Subject: Three Mile Island Nuclear Station, Unit 1 (TMI-1)
Operating License No. DPR 50
Docket No. 50-289
GPU Nuclear Response to NRC Request for Additional
Information Regarding the TMI-1 20th Year Reactor Building
Tendon Surveillance Test

**GPU NUCLEAR CORPORATION
THREE MILE ISLAND UNIT 1
TENDON SURVEILLANCE PROGRAM
RESOLUTION OF NRC QUESTIONS**

FIGURE 3.1

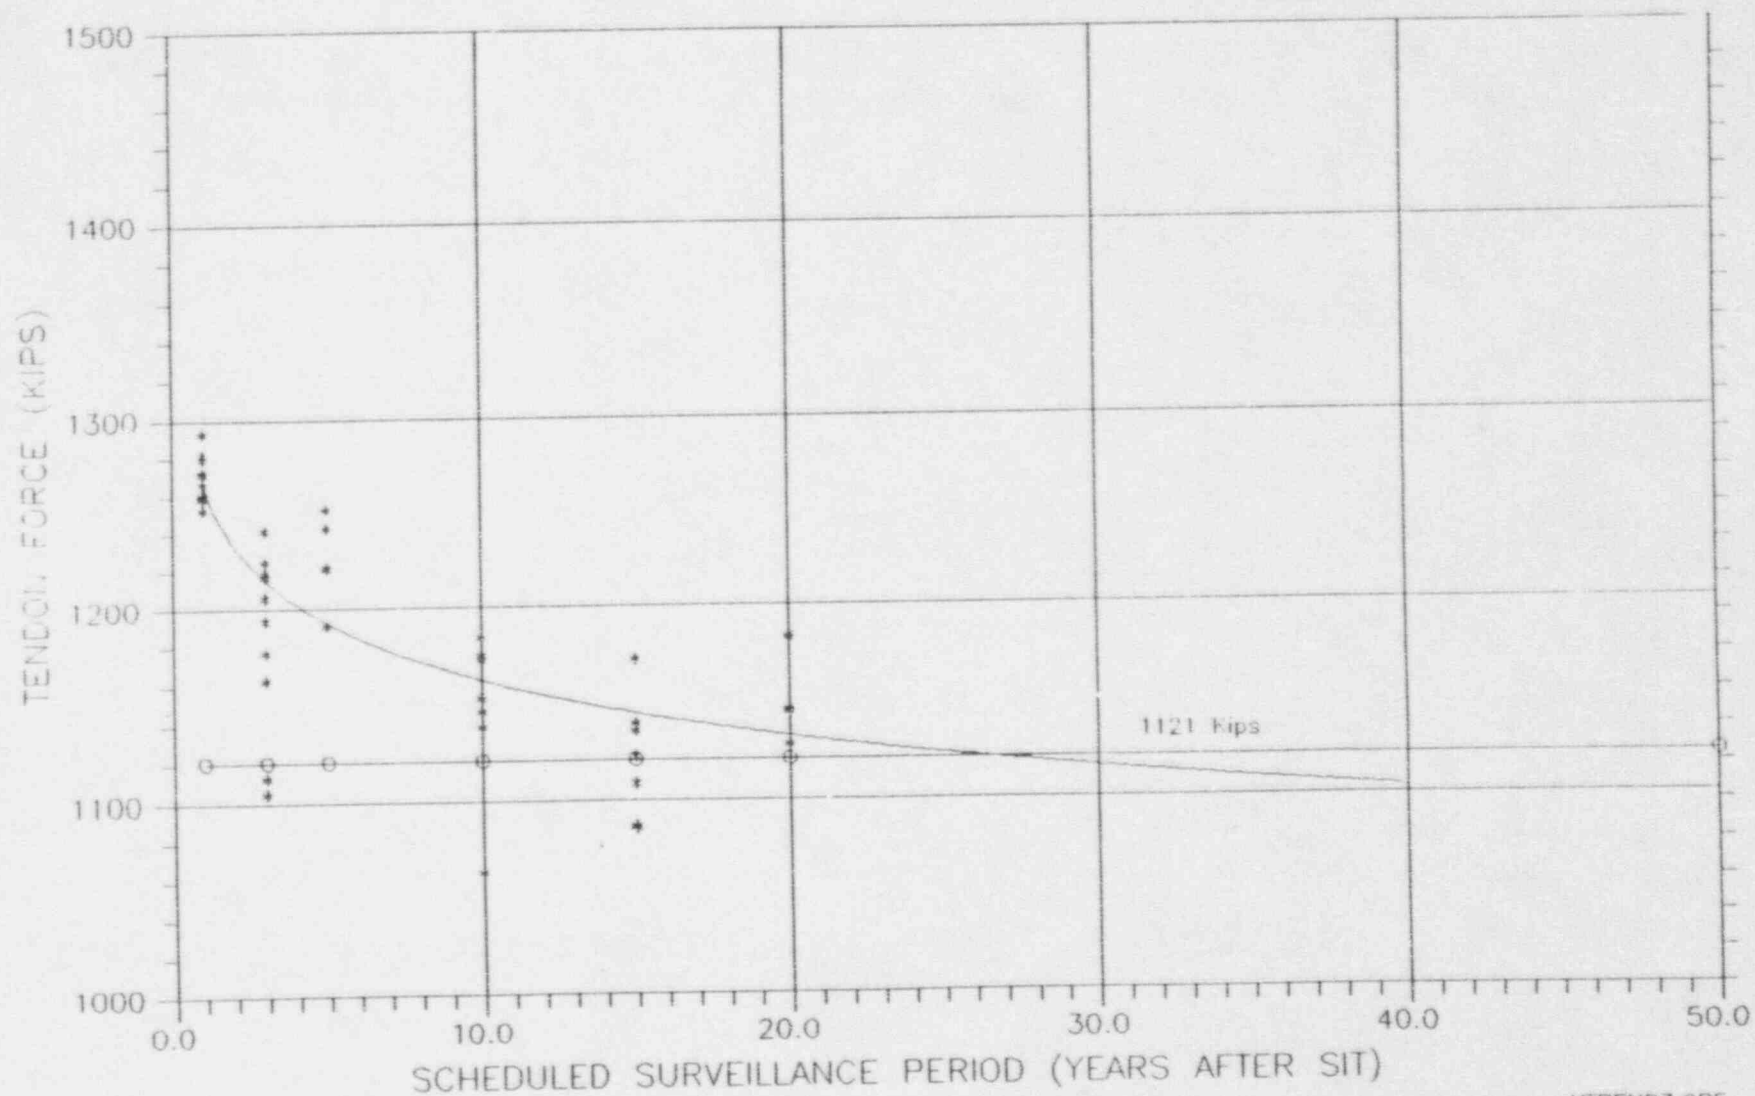
For the Attachment B and other similar Figures within the Topical Report, explain how the lift-off force is represented by one value. Explain how this representative force is established and how the trend line was obtained. All the tendon lift-off forces for all surveillances should be used without any normalization and linear regression analysis should be performed to obtain the trend.

With respect to the linear regression, GPU Nuclear reviewed the tendon lift-off data points from all prior surveillances and concluded that the prestress loss was indeed larger in the early life of the plant, and that these losses now have leveled off significantly. A pure linear regression of the data points is therefore not appropriate and is not used. The curve selected is a best fit among all the data points considering a steeper slope in the initial years, and leveling out as losses are shown to have stabilized. The curve for the hoop tendons was prepared using engineering judgment as a best fit for the data points and is shown as Attachment B in the Topical Report.

Utilizing the data from Topical Report Attachment B, the hoop tendon curve has been duplicated herein using a mathematical regression best fit curve as shown in the attached Figure 3.1. This curve utilizes all lift-off points without being normalized. The results of this curve show that the regression line may fall below the minimum required prestress force for the hoop group in about 6 years. While this curve differs slightly from the curve contained in the Topical Report, it still shows that the tendon force values are expected to be above the minimum required value at the next surveillance. A similar curve will be generated after the next surveillance period to determine if forces remain at acceptable levels. If the results obtained in the 25th year surveillance indicate that forces would be expected to drop below the minimum required value, GPU Nuclear would take appropriate action.

Figure 5.1
Tendon D248 : Force-Elongation relationship during retensioning

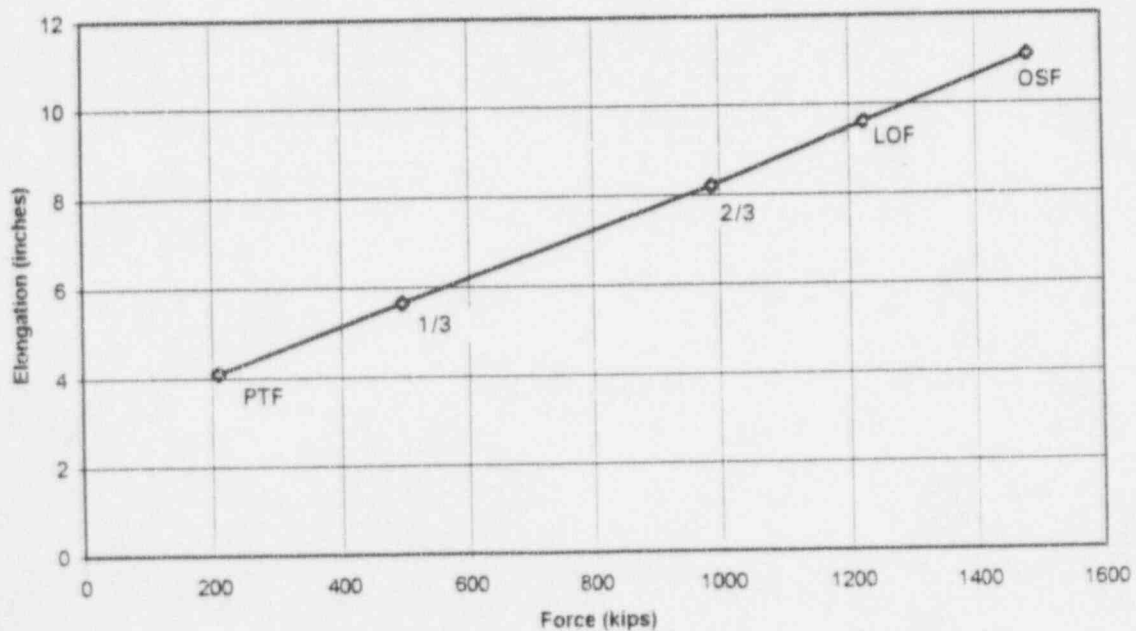
Provide force-elongation information in the requested format for each detensioned and retensioned tendon at the required 1/3 and 2/3 increments as required by Regulatory Guide 1.35. Prepare graphs showing the linear force-elongation relationship for each tendon. Explain and discuss the implications if not linear.

Figures 5.1, 5.2 and 5.3 were also prepared as requested and are attached. These figures represent the plotted force-elongation relationship for the three retensioned tendons.

The resulting force-elongation plots show very good linearity as the tendon is retensioned through the 1/3 and 2/3 increment points and up to the OSF. The graphs of all three tendons show excellent linear correlation between the measured incremental elongation and the force in the tendon during the retensioning process. For Hoop Tendon H35-47, the LOF is somewhat off the linear slope. This condition occurs because the shims have a finite thickness and can compress under load. This results in the LOF being a step function rather than a linear function. The LOF point is also taken after reversing the tensioning direction downward from the OSF, rather than during the retensioning process as all other points are established.
